**From:** [Andress, Lane, NMENV](#)  
**To:** [Pierard, Kevin, NMENV](#); [Cobrain, Dave, NMENV](#); [Murphy, Robert, NMENV](#); [Wear, Benjamin, NMENV](#)  
**Subject:** RE: data gap letter  
**Date:** Thursday, June 25, 2020 9:16:30 AM  
**Attachments:** [image002.png](#)

KAFB5123

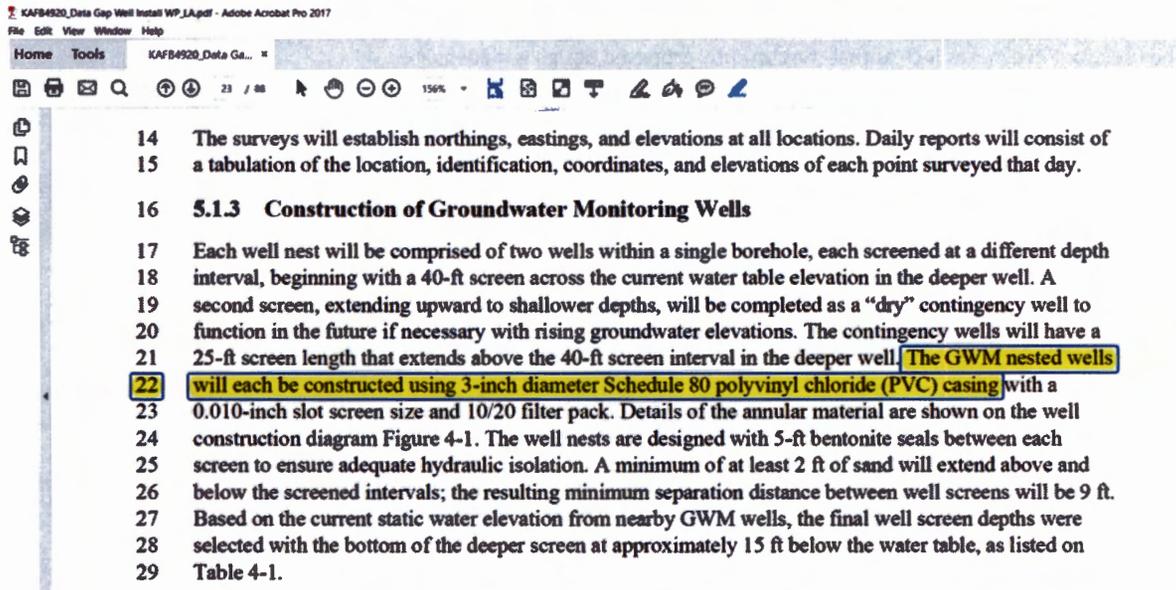
To answer your question, yes, the work plan had 3-inch wells. Here is a snip from the approved old 2017 work plan:
